Proposed Reliability Standards and Definitions

Proposed Reliability Standard PRC-027-1

1. **Title:** Coordination of Protection Systems for Performance During Faults
2. **Number:** PRC-027-1
3. **Purpose:** To maintain the coordination of Protection Systems installed to detect and isolate Faults on Bulk Electric System (BES) Elements, such that those Protection Systems operate in the intended sequence during Faults.
4. **Applicability:**
 - 4.1. **Functional Entities:**
 - 4.1.1. Transmission Owner
 - 4.1.2. Generator Owner
 - 4.1.3. Distribution Provider (that owns Protection Systems identified in the Facilities section 4.2 below)
 - 4.2. **Facilities:** Protection Systems installed to detect and isolate Faults on BES Elements.
5. **Effective Date:** See the Implementation Plan for PRC-027-1, Project 2007-06 System Protection Coordination.

Process Flow Chart for Coordination of Interconnected Protection Systems (PS)

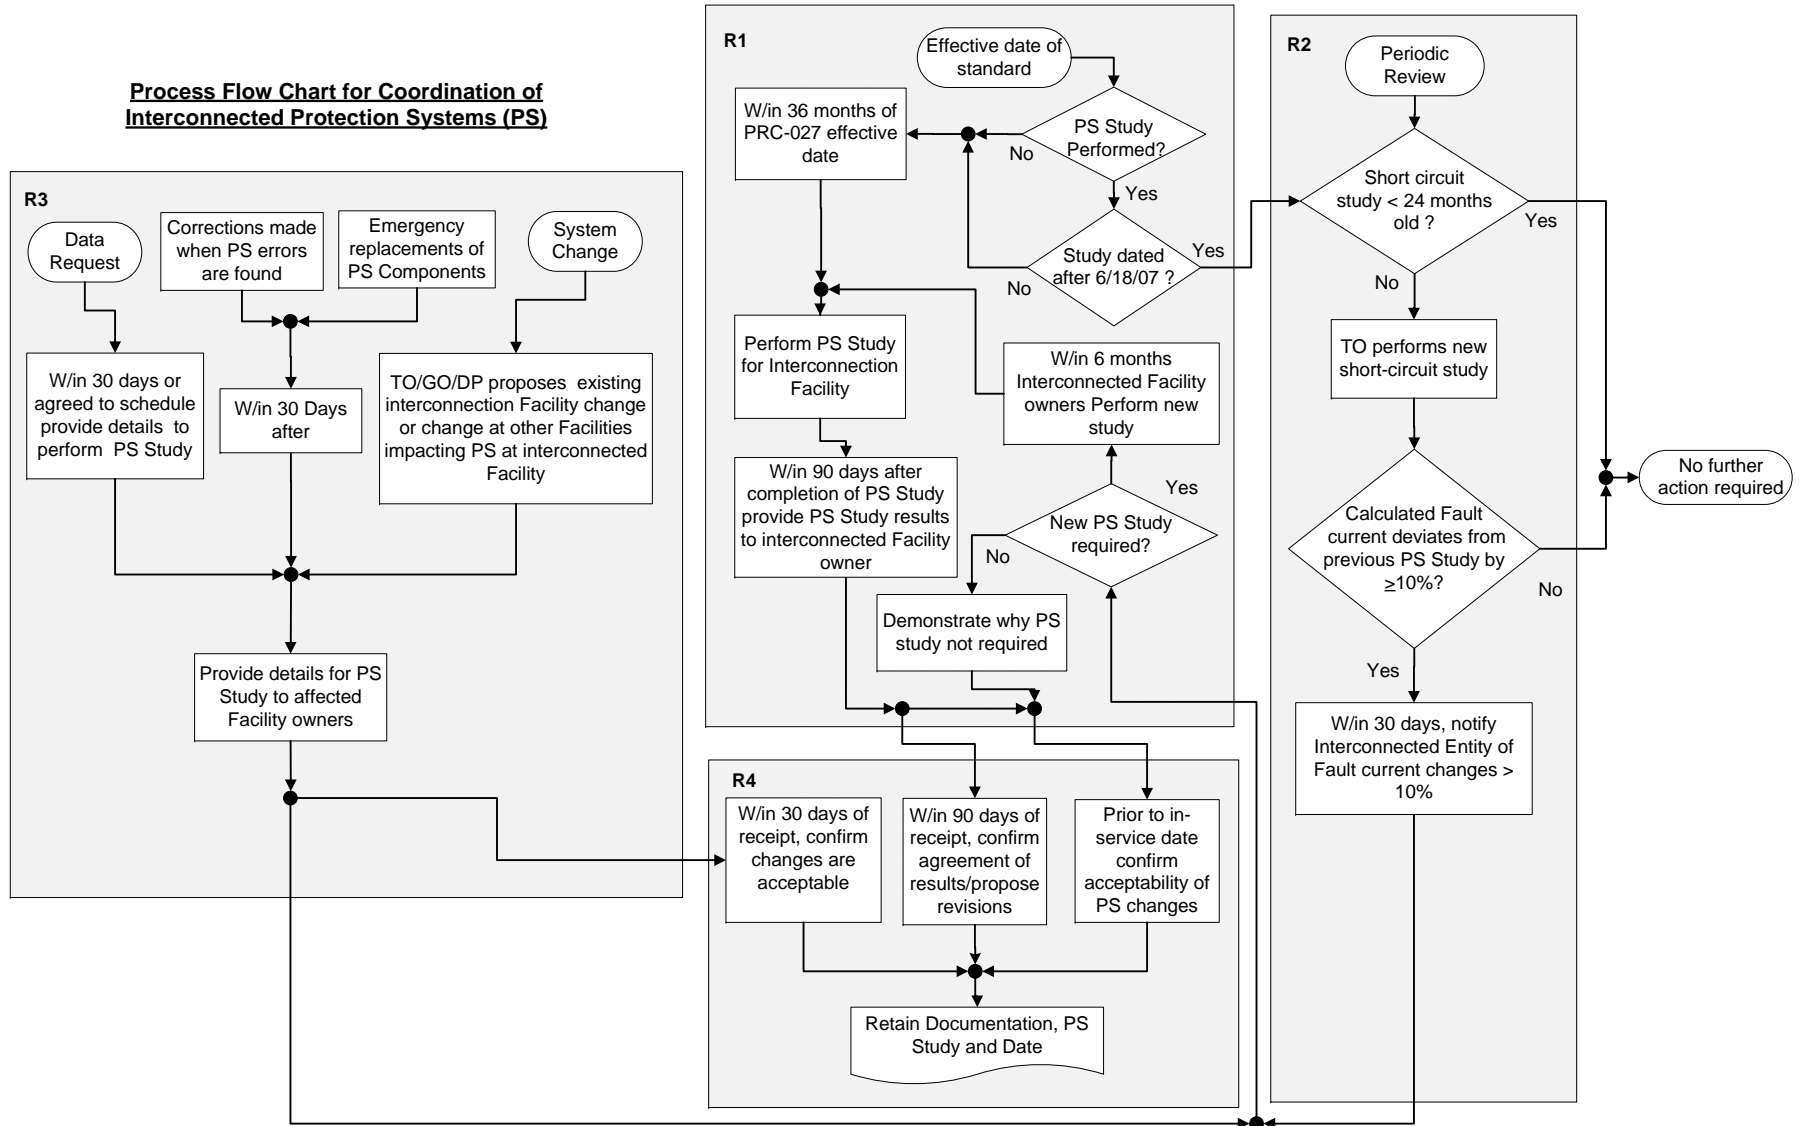
flowchart on page 21 shows a system change that triggers the need for a new study leading to a box that requires the study be performed within six months. Please remove the conflicting information. (2) AE supports a timeframe that requires a Protection System Study in accordance with a mutually agreed-upon schedule that includes confirmation of agreement with summary results (per R4.1) prior to the in-service date of any planned change. AE suggests the SDT identify this timeframe in R1.1.3 and delete R4.2. (3) AE requests that the SDT change the values in the % Deviation formula (R2.2) from VSCS and VPSS to ISCS and IPSS since V is typically used for voltage. AE also requests the SDT change the variable definitions from "fault current value ..." to "fault current magnitude ..." to clarify that the phase angle is not included.

Figure 3

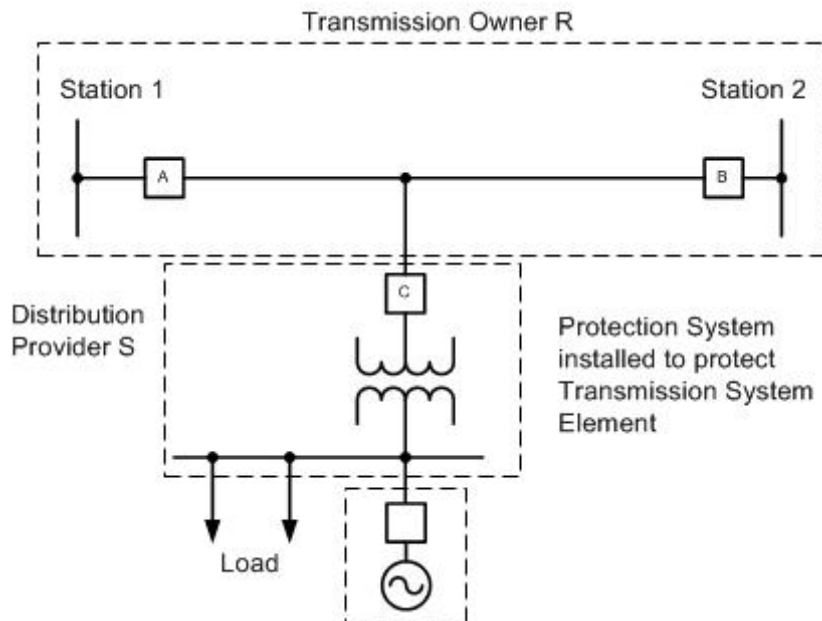
For example, Generator Owners and Transmission Owners. 3. Application Guidelines Fig. 3 requires the TO to verify that the DP's and the GO's protection systems coordinate with the TO's, even though the GO doesn't connect directly to the TO. It should be the DP that checks coordination of the GO with the DP for faults on the transmission side of the DP's substation transformer, and the TO that checks coordination of the DP's transmission protection with the TO. If all of the transmission protection is back at the GO (in other words the DP has installed no transmission protection at its sub) then to do as this app guide suggests the TO will require an accurate short circuit model of the DP's system between the GO and the TO. It would require that the DP keep the TO continuously appraised of changes to the DP's system that impact the short circuit representation. Considering the proliferation of distributed generation being interconnected to distribution systems the burden should be on the DP not on the TO supplying the DP to verify coordination. The scope of the text "...generator protection systems..." should be narrowed so a TO or DP is not responsible for the coordination of devices it doesn't own, maintain or set.

the drafting team. However, we recommend revising the example regarding Figure 3. It would appear to assume a distribution level generator is part of the BES and subject to NERC standards. While it is possible for a generator on the distribution system to be part of the BES (i.e. if it is a Blackstart Resource), inclusion of such a generator would be unusual and an exception to the normal BES 100 kV threshold. If the generator is not part of the BES, there would be no Generation Owner registered to perform the coordination. Industry is likely to be sensitive to such an example. Removing the generator will still allow the example to communicate that a breaker and associated Protection System on the high side (100 kV or higher) of a distribution or step-down transformer would still have to be coordinated.

The drafting team revised the description relating to Figure 3 in the “Guidelines and Technical Basis” to clarify that only the Distribution Provider’s Protection Systems installed to protect for Faults on Transmission System Elements are a part of the Applicability of this standard. The drafting team modified Figure 3 to indicate that the source could be a generator or a network system.
